Further Information

**Proposed Temporary Holiday Camp, Place of Recreation, Sports or Culture
(Barbecue Site and Hobby Farm) and Eating Place with Ancillary Facilities for a Period of 3 Years
and Associated Filling of Land in "Agriculture" and "Open Space" Zones and Area shown as 'Road',
Various Lots in D.D. 17 and Adjoining Government Land, Ting Kok, Tai Po, New Territories**

(S.16 Planning Application No. A/NE-TK/832)

Response-to-Comment (RtC)

FIGURE NUMBER
FIGURE 3

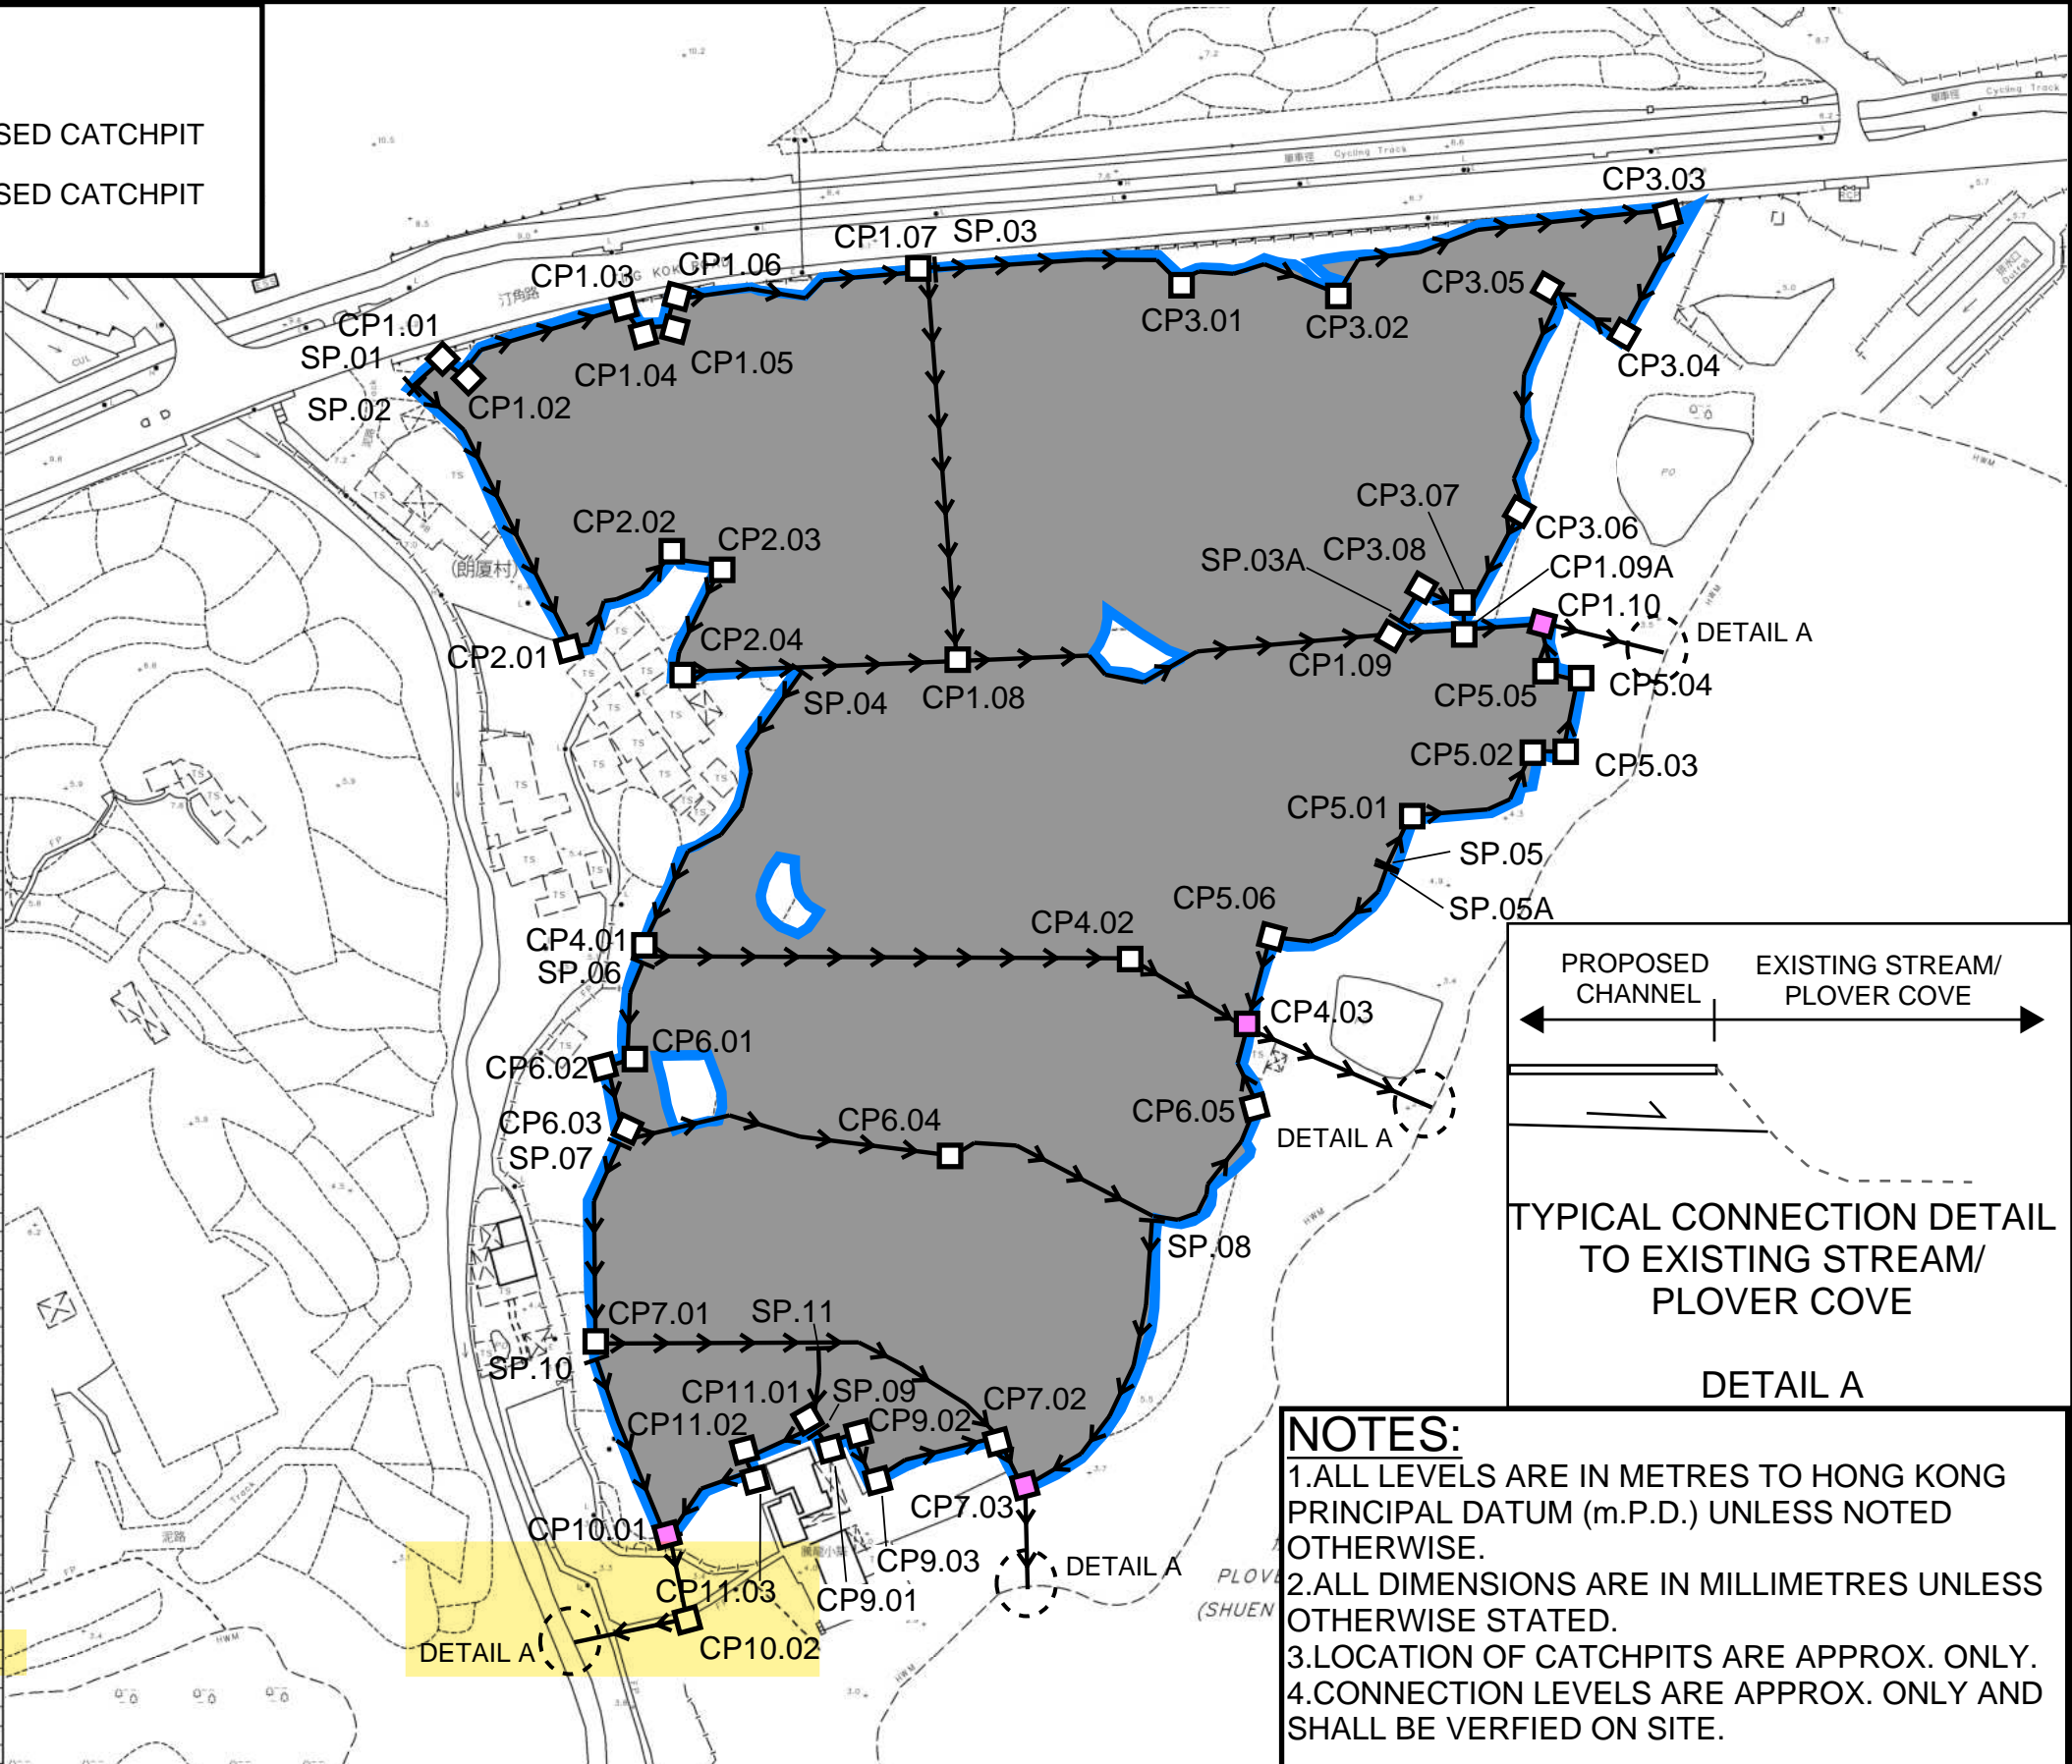
Departmental Comments		Applicant’s Responses
1. Comments of the Chief Engineer/Mainland North, Drainage Services Department (CE/MN, DSD)		
(a)	It is noted that the proposed drainage system (proposed 375UC at downstream of catchpit no. CP10.01) will run through the application site of A/NE-TK/778. The applicant shall demonstrate that the proposed drainage construction works and the operation of the drainage can be practicably and satisfactorily implemented on site.	Noted. The downstream of catchpit No. CP10.01 has been revised to avoid conflict with the application site of A/NE-TK/778. Please find the updated Figure 3 and 4 in the revised Drainage Impact Assessment at Annex 1 .

FIGURE 4

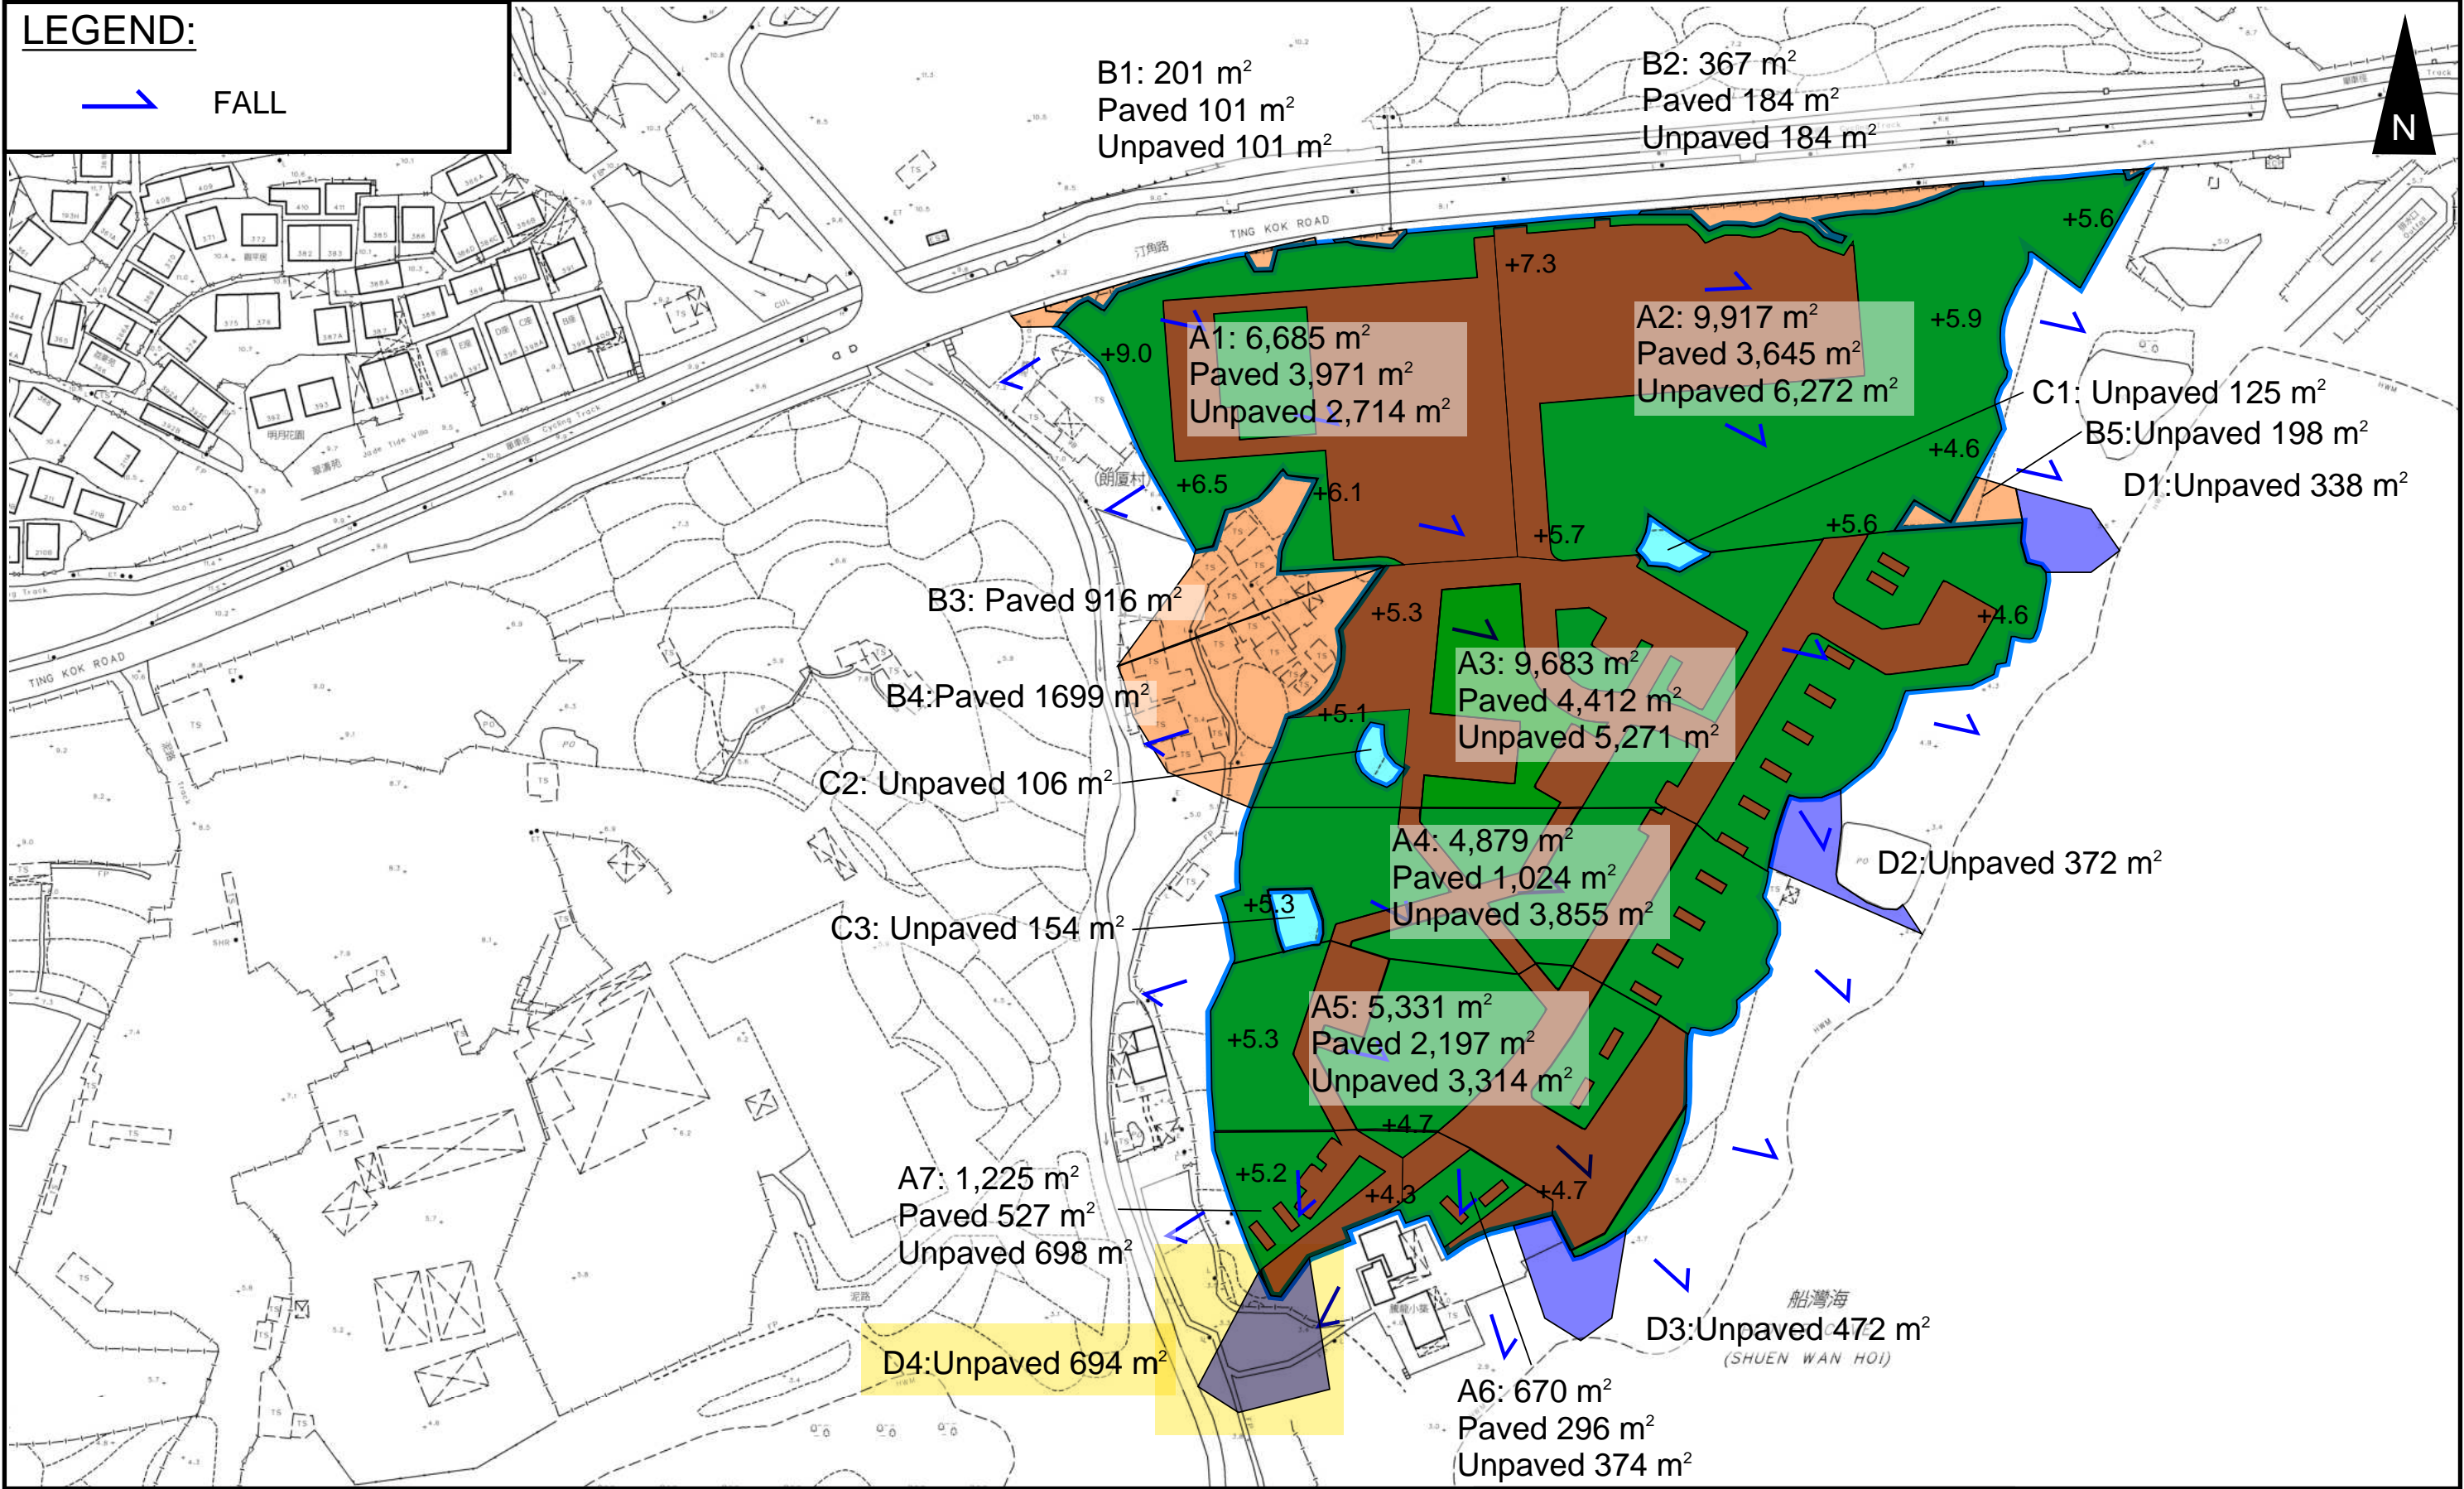
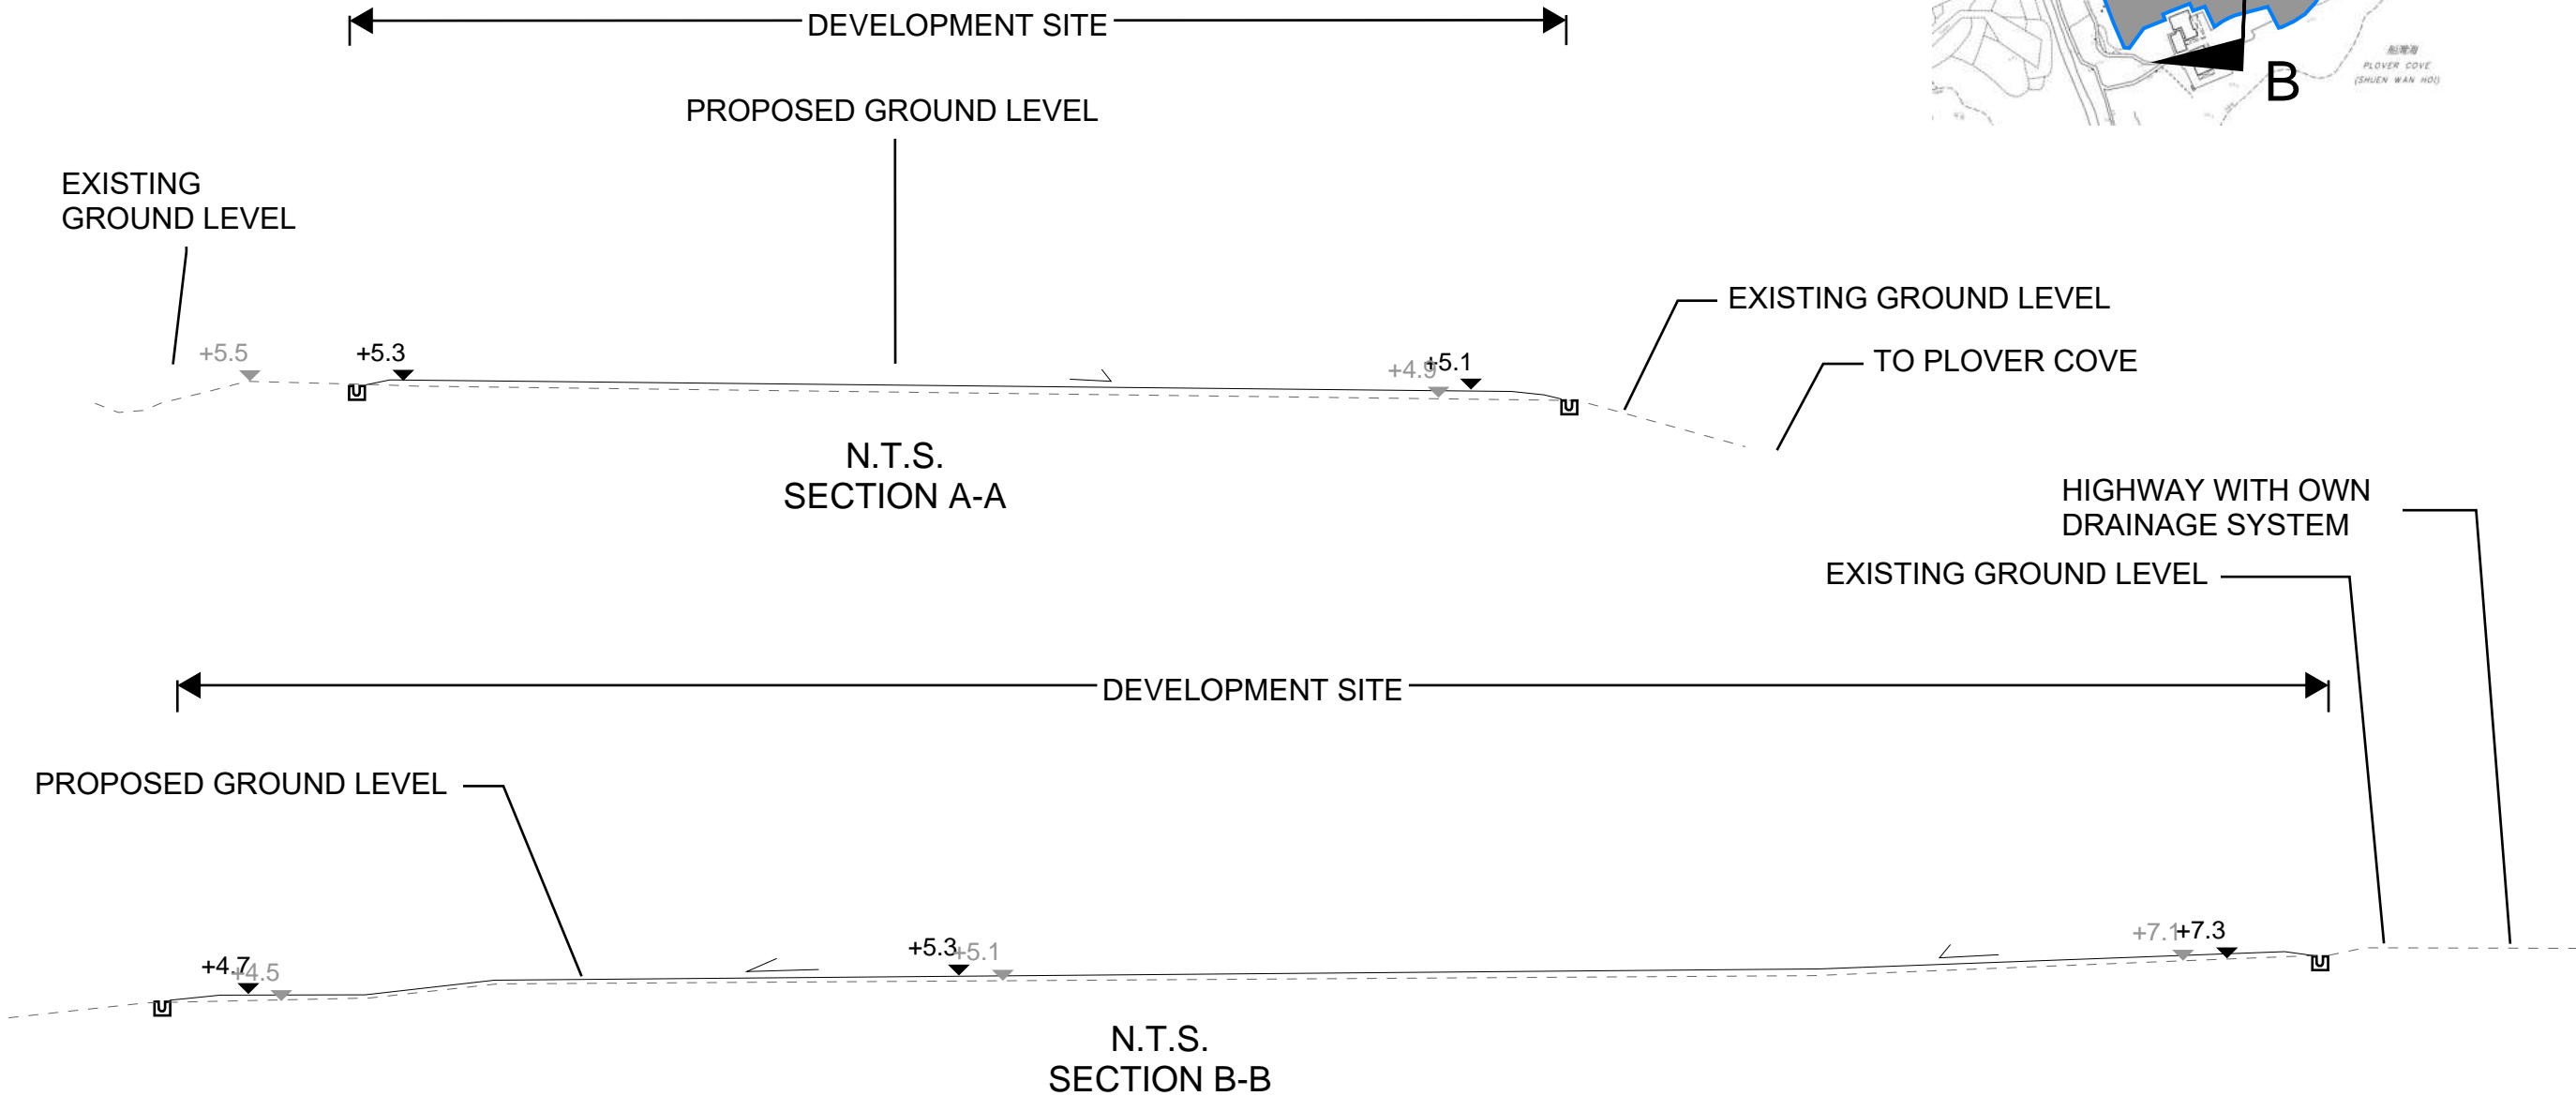
(b)	Figure 4 refers. (i) Please specify the type of u-channel cover to be adopted. (ii) For safety concern, please review the depth of the proposed u-channels. (iii) The hard paved areas of Catchment C3 and C4 shown in Figure 4 are not consistent with those in Appendix A are different. Please clarify.	Noted. (i) The type of u-channel cover will be concrete. (ii) Noted. The depth of proposed u-channel is revised and not deeper than 1.18 m. (iii) Noted. The typo in Figure 4 has been updated.
